AIA Document G701™ – 2017

Change Order

PROJECT: (Name and address)
Williamson County
Animal Shelter Expansion
1855 SE Inner Loop
Georgetown, TX 78626

CHANGE ORDER INFORMATION:
Change Order Number: 003

A.1-2.10

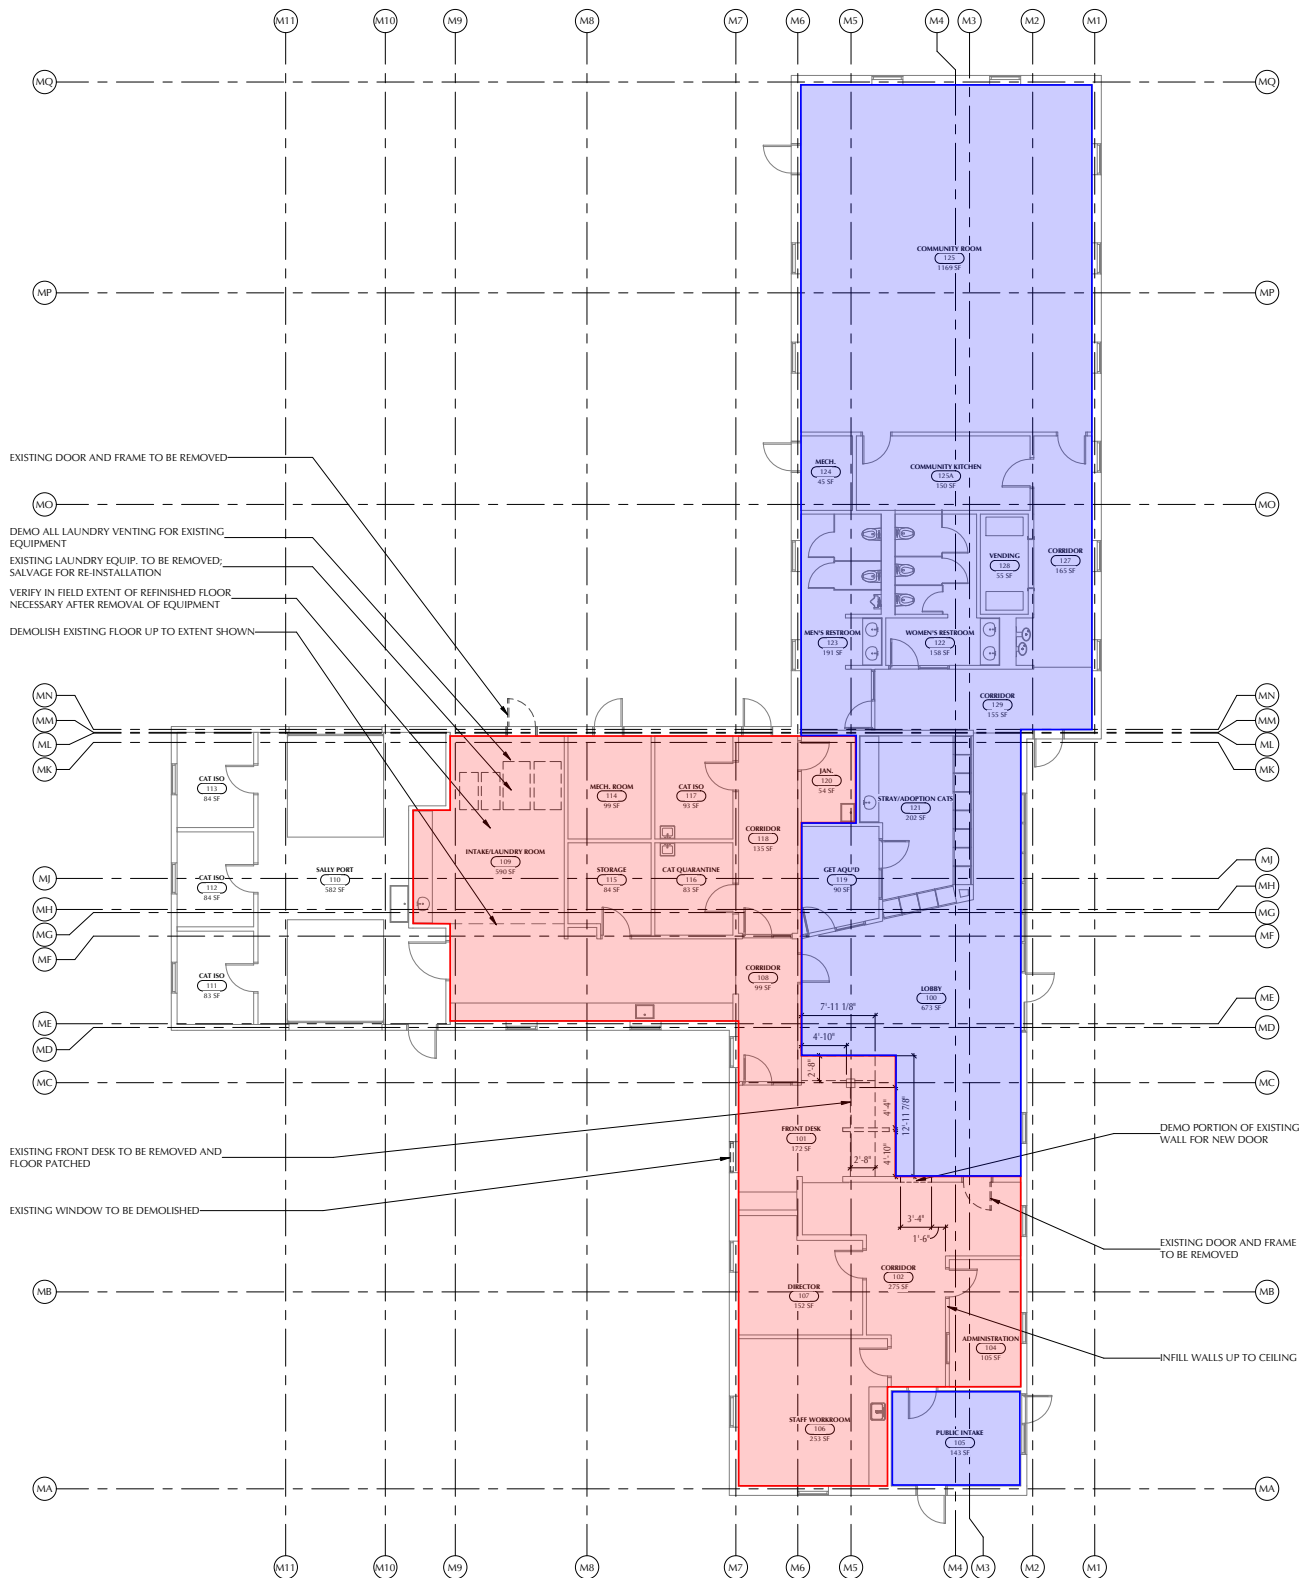
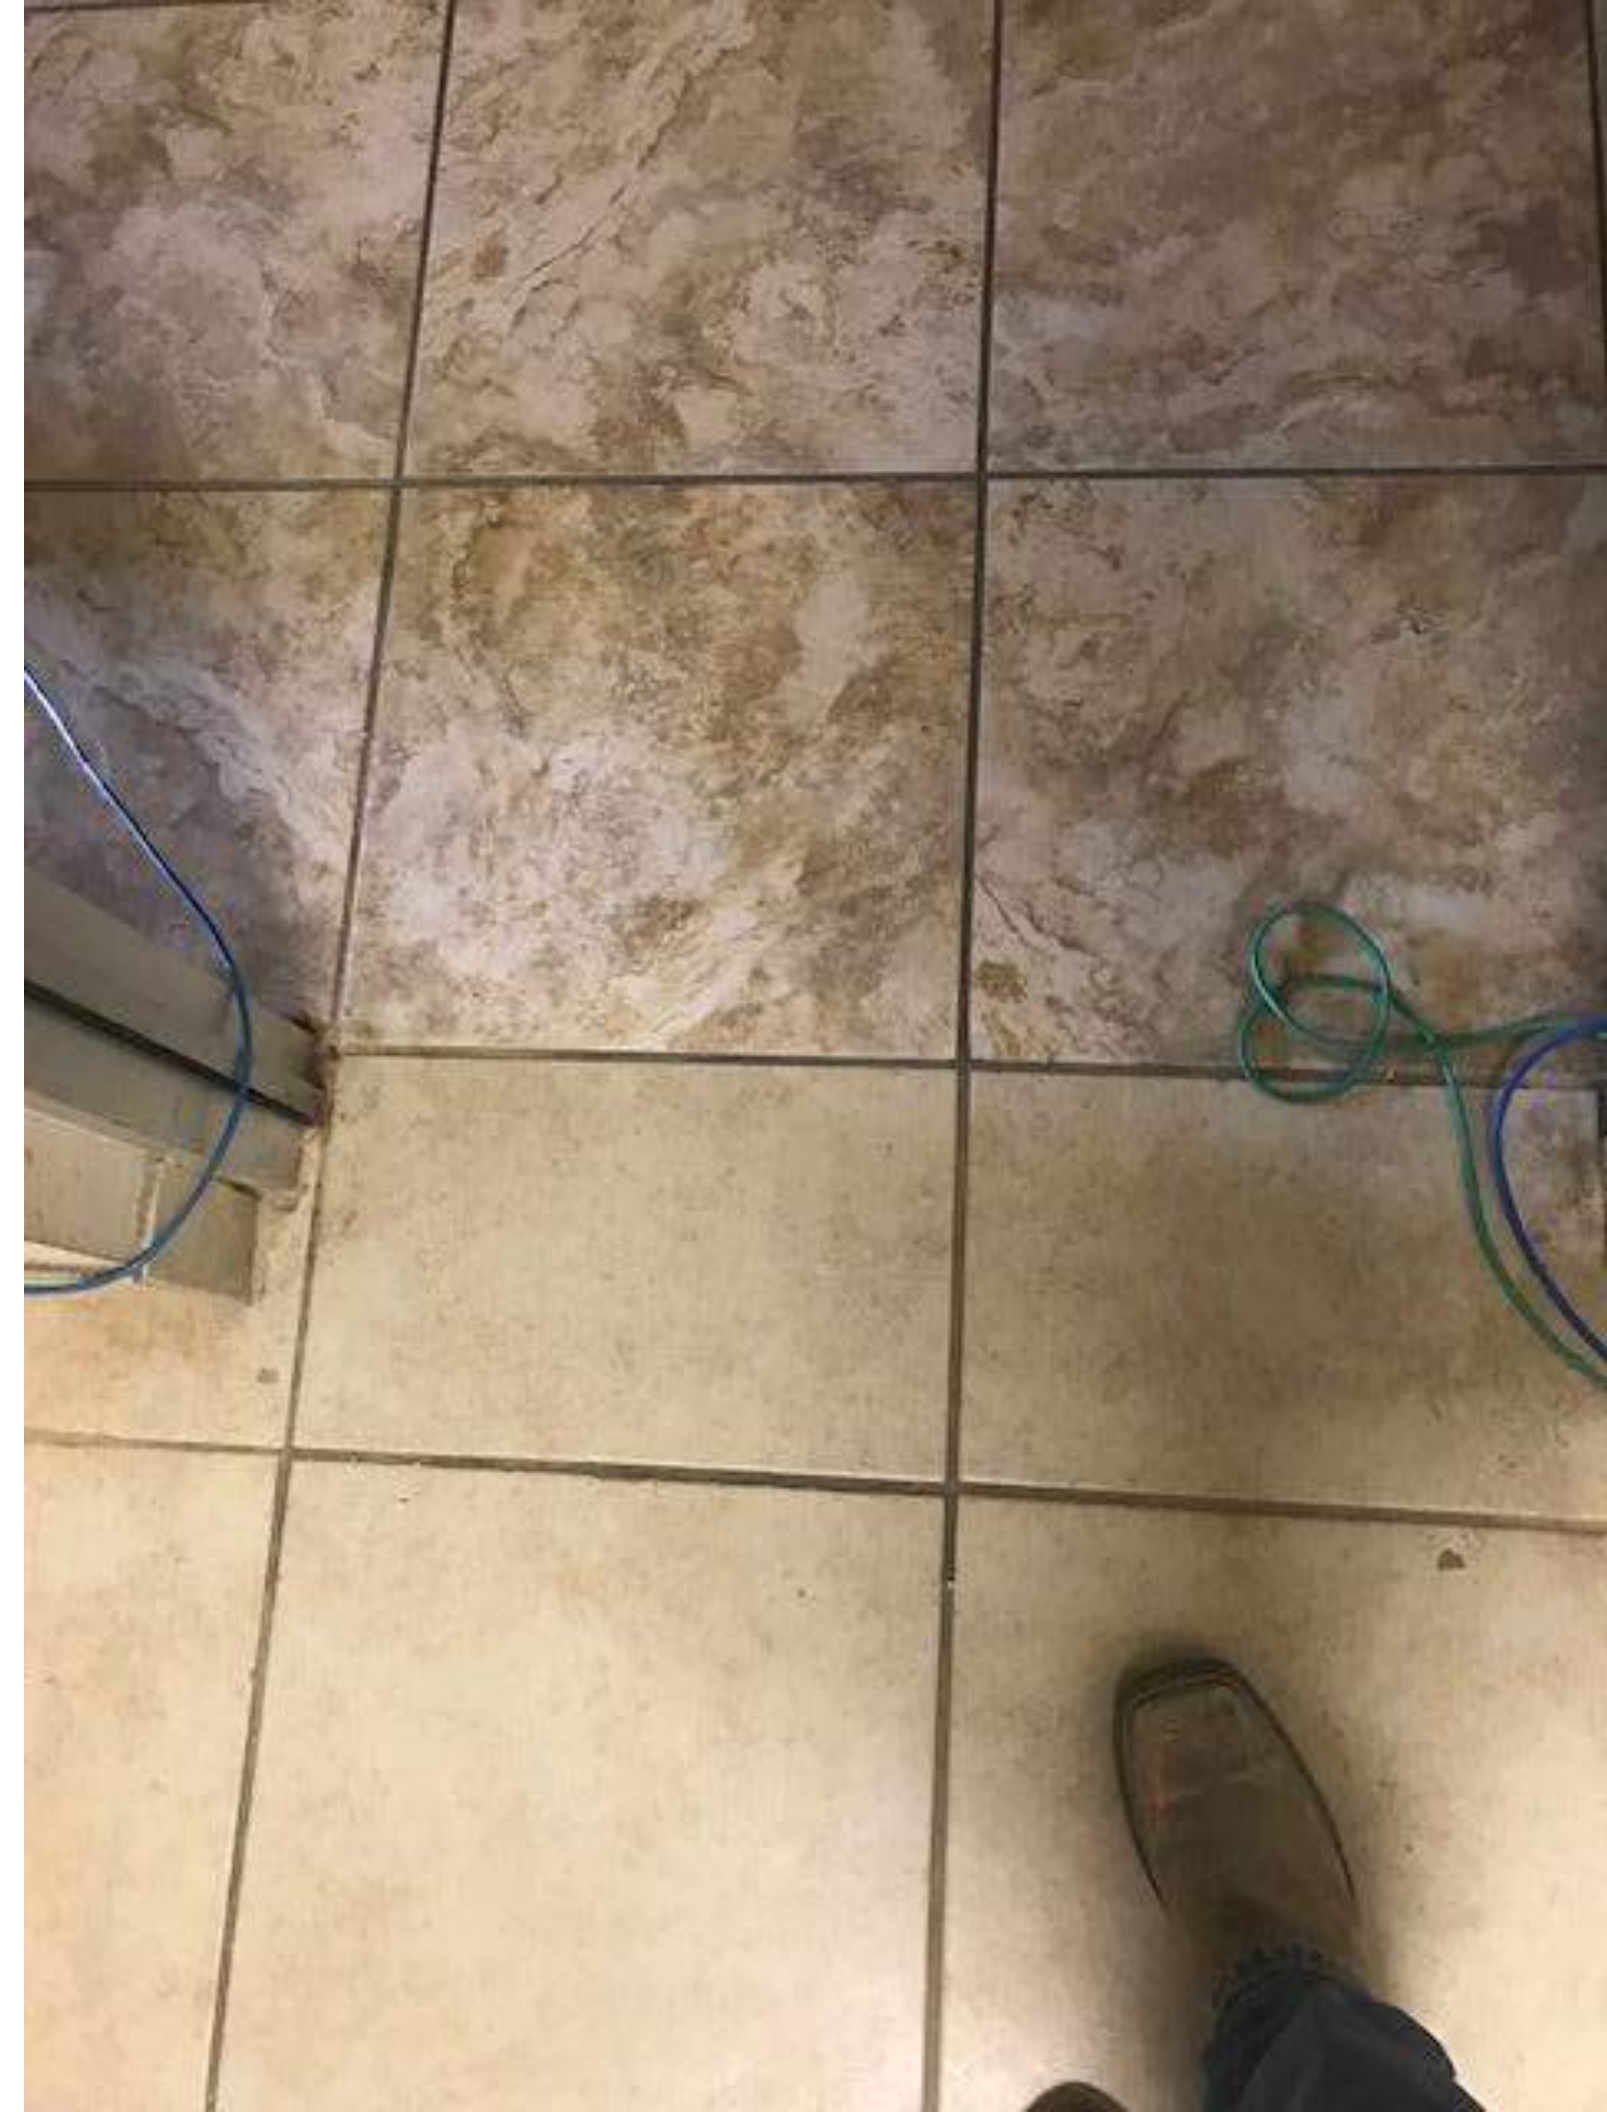
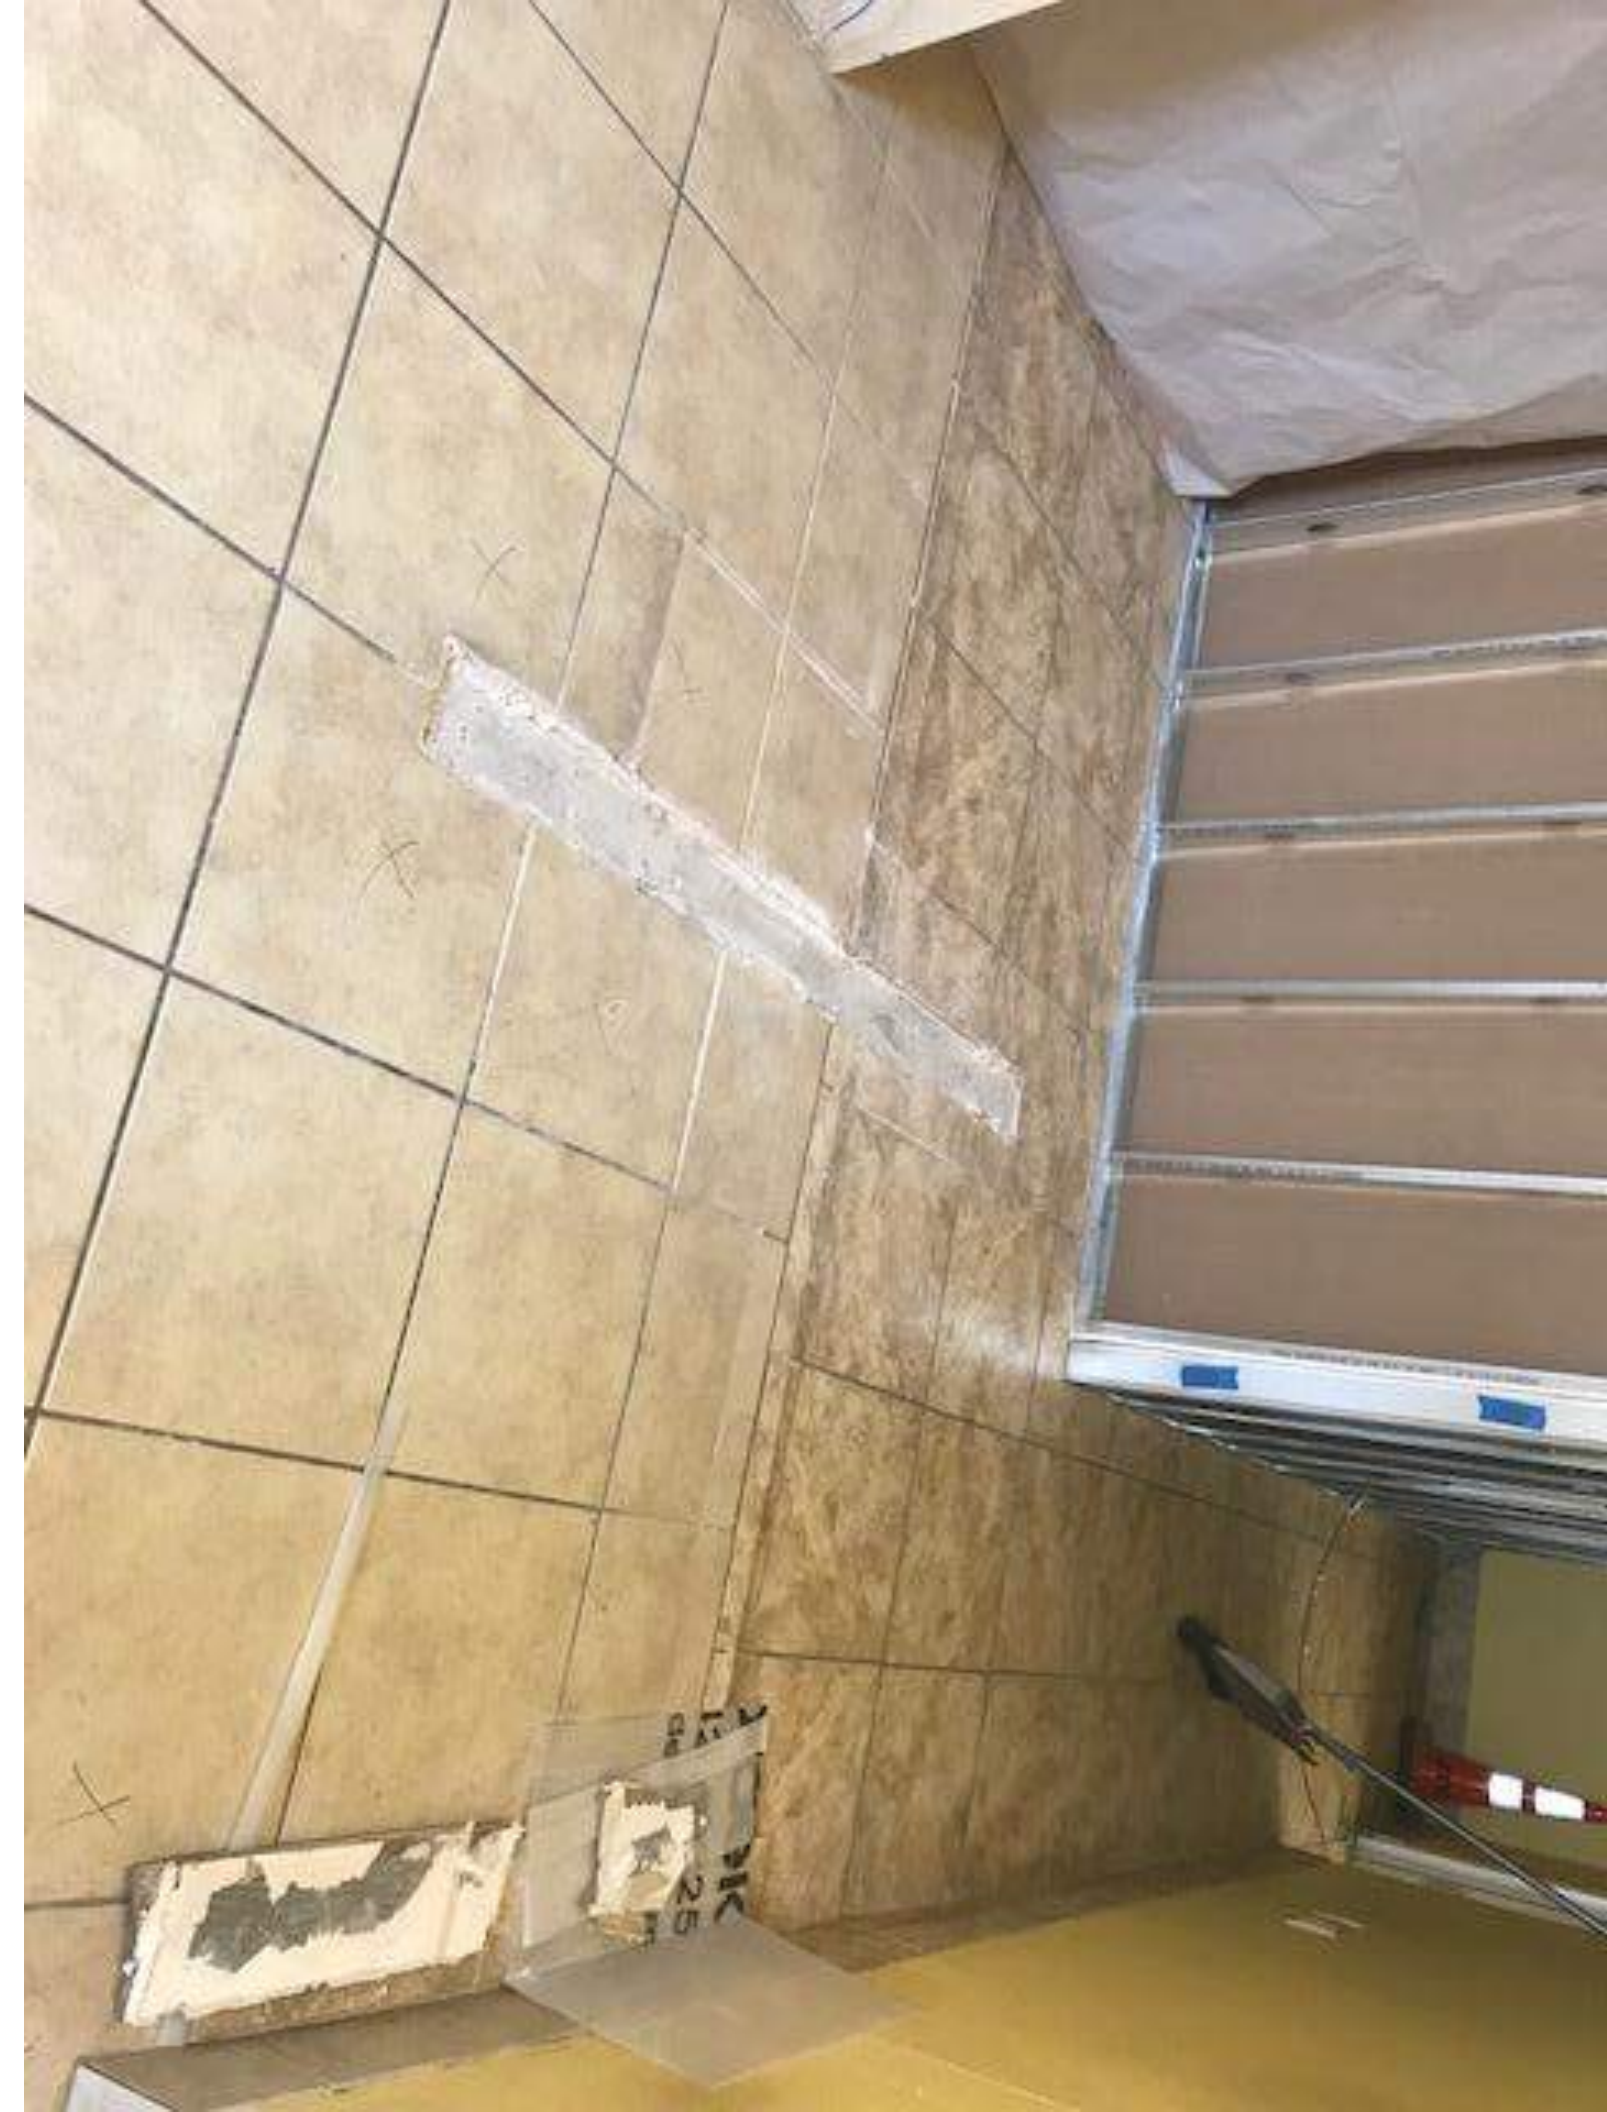
Sheet A.1-2.10 has a note to patch the tile flooring around the demolished existing lobby desk. This area has 2 different tile types (see attached) that are laid out in the middle of the lobby making patching and/of matching any tile very difficult as there will be a distinct transition on the visible lobby floor. Also, the county has confirmed that there is not attic stock of either tile.

WilCo found it acceptable to propose a defined area of further demolition of the existing floor tile and replace it with new floor tile, to match generally the size and pattern. Shelter Management requested the new tile be darker than the existing.

See revised Architectural sheet A.1-2.10, attached.
